Project: **Symes Mews - Camden**
Prepared By: **Annie Marston**
Status: **For Information**
Reference: **WED14117**
Design Note: **Response to comments from Planning Submission**

Date: **22 March 2019**

Issue: **B**

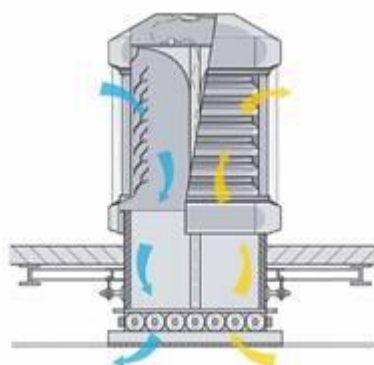
- Claimed not “compatible with the proposed cooling system” – not demonstrated or evidenced. Air source heat pumps provide cooling as well as heating. We would expect the proposed cooling system to be designed in the context of sustainability and air quality, not being assumed and overriding other design choices.

The mechanical scheme is centred around a naturally ventilated and cooled building, designed to CIBSE AM10. The proposal is to incorporate automated window/trickle vent actuators around the building to allow air ingress. Exhaust air shall be via ventilation stacks at the rear of the building, which will promote air movement within the space and achieve the requirements of Approved document Part F. The upper floors will incorporate windcatchers (image below) or actuated windows to achieve the ventilation and cooling requirements

Heating and hot water will be achieved by a centralised gas fired boiler serving perimeter radiators and storage calorifiers. During the cooling season the boilers will only provide the hot water requirements for the building.

Altering the mechanical scheme to air source heat pump (ASHP) will result in an increase in annual CO₂, as currently there is no mechanical cooling element to the building. ASHP will also require the introduction of air handling units, as opening windows and mechanical cooling conflict with each other and cause energy use to increase.
